M54 to M6 Link Road

TR010054

8.5 Formal Request for Scheme Changes

October 2020

NOTES

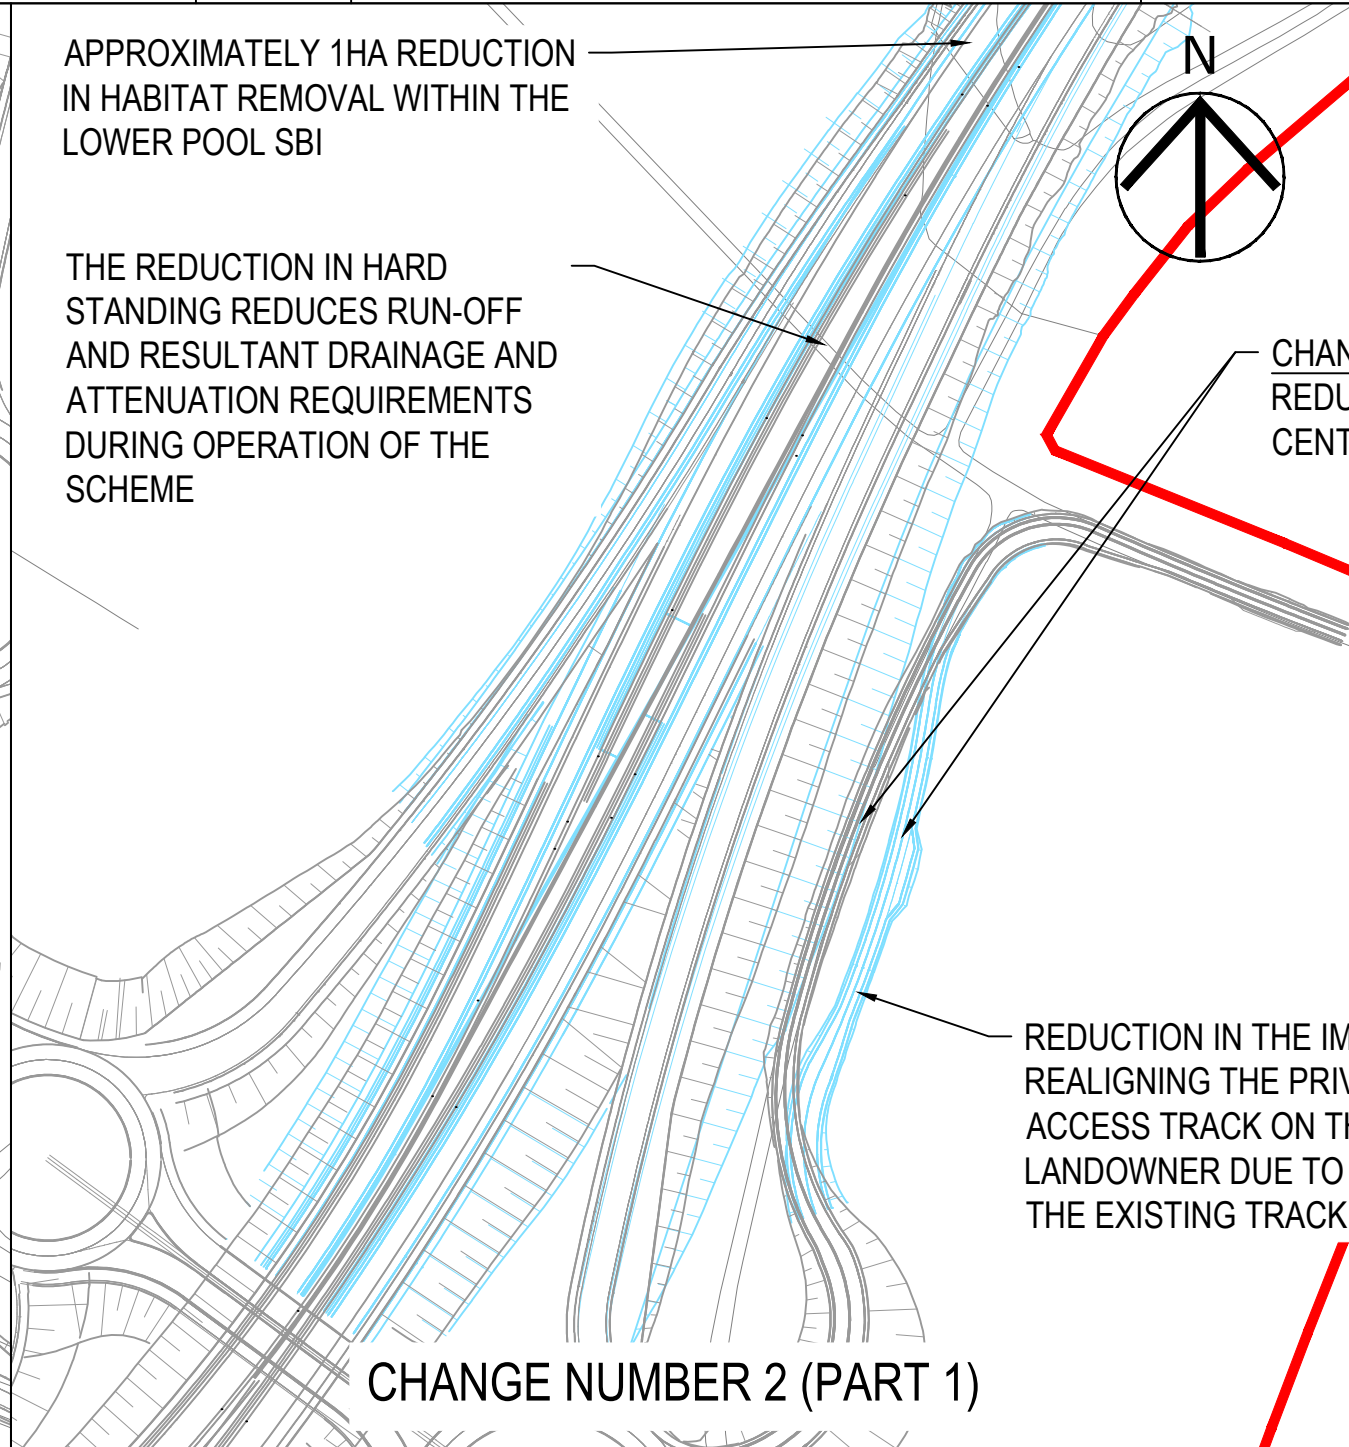
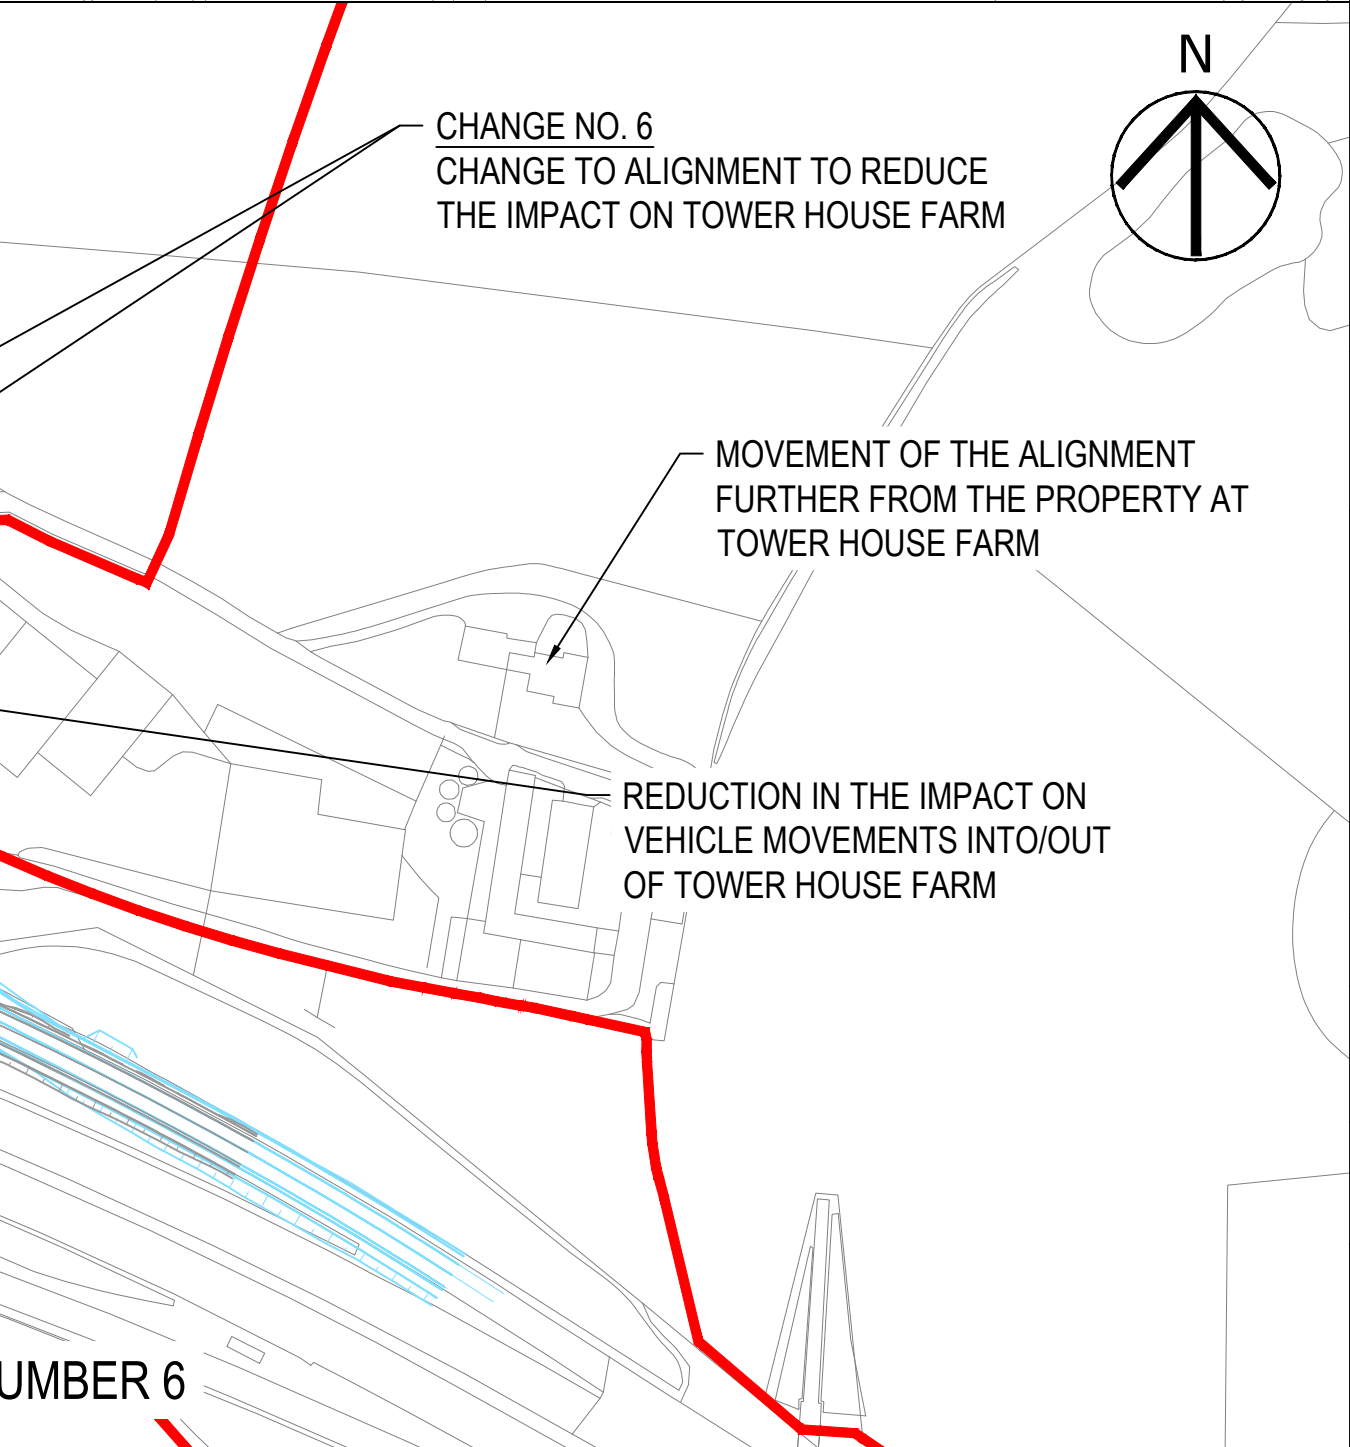
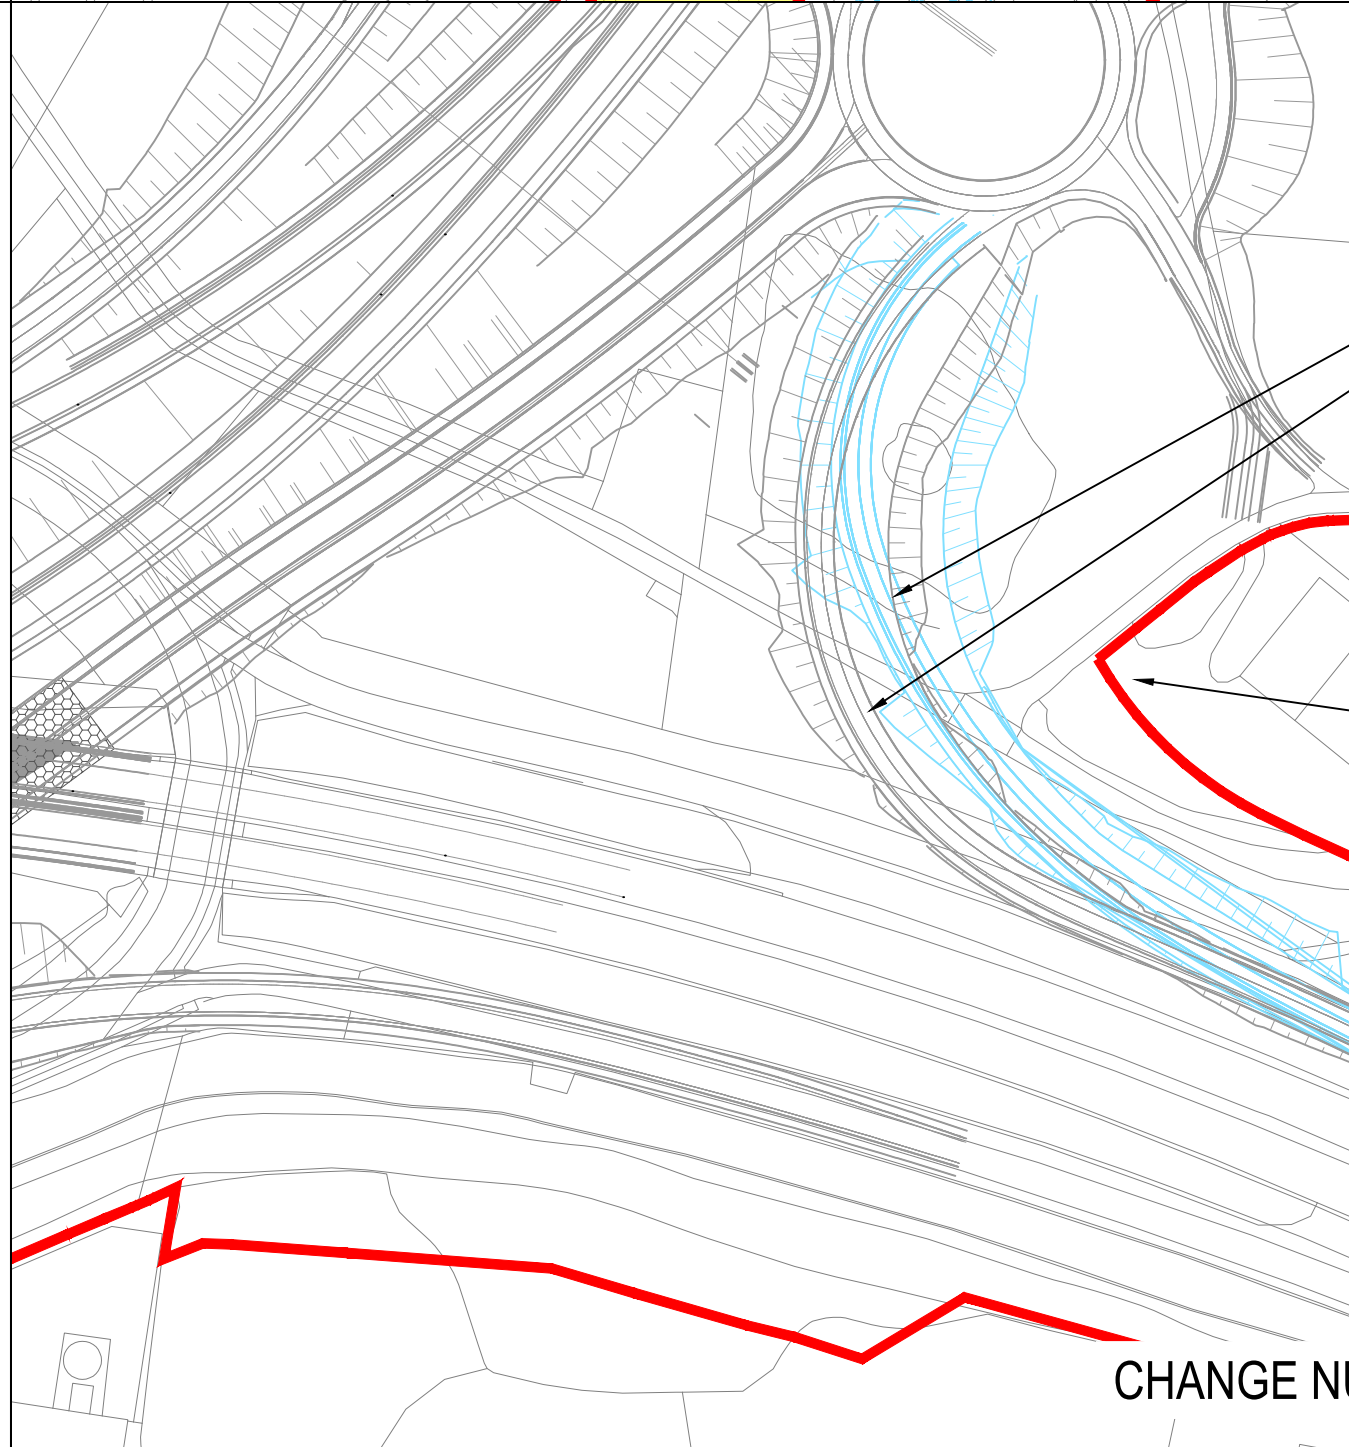
- 2.2.2 This change proposes a minor realignment of the eastbound exit slip road to Featherstone, reducing the length of the slip road to the dumb-bell junction. This will bring the road closer to the junction and reduce the overall size of the junction.

- 2.3.2 This proposed change would reduce the overall width of the link road by reducing the width of the central reserve from 4.5 m to 3 m along the length of the new link road and reducing the width of the verge area by putting the surface water channel in the verge rather than adjacent to it. There would be no reduction to the width of traffic lanes or hard strips.

2.4.2 This change would reduce the height of the approach to M6 Junction 11 by approximately 0.7 m where the road passes through an area of woodland near Latherford Brook. This change would increase the gradient of the approach to the Junction. However, the gradient would be within the recommended design for dual carriageway standard, with a maximum 2% gradient at the stop line to reduce the risk of vehicle roll back. Therefore no safety impact is anticipated as a result of this change. A minor change has also been incorporated to the diversion route of Saredon 8 Public Right of Way as a result of changes to the embankment.

- 2.5.1 To provide free-flow links between the M54 and the new link road, the Scheme included construction of a new bridge to carry the roads through the redesigned M54 Junction 1. The original Scheme would have taken a period of approximately two years to build the bridge in sections at its final location. This would need complex and long-term traffic management for over two years on the M54, over several phases, including contraflows, narrow lanes and lane closures as well as several overnight closures with night-time working. The proposed change utilises an innovative construction solution negating the need for two years of traffic management. It involves constructing the bridge as two simpler structures in a nearby site compound to the north-east of the junction and moving them into position when ready. To do this safely, the change would require the closure of the M54 over Junction 1 and some of the slip roads for up to three weeks. Building the bridge as two simpler structures also enables the movement of the road alignment by 20 m, which will reduce the size of Junction 1.

- 2.6.1 Near Hilton Lane, the new link road will be below existing ground level and Hilton Lane will cross the link road via a new bridge. Following further work to review the Scheme construction methods, it is proposed to build the Hilton Lane bridge to the north of its current proposed location. This change would enable the retention of more of the existing route of the Public Right of Way (PRoW) [Shareshill 5] across nearby land rather than routing it alongside the link road as is currently proposed in the DCO application.

- 2.7.1 This change is proposed to alter the alignment of the slip road between the M54 Junction 1 eastern dumbbell roundabout and the M54 eastbound to the west of the position shown in the original application. This change aims to address concerns raised by the landowner at Tower House Farm that the Scheme will adversely impact access to the site.
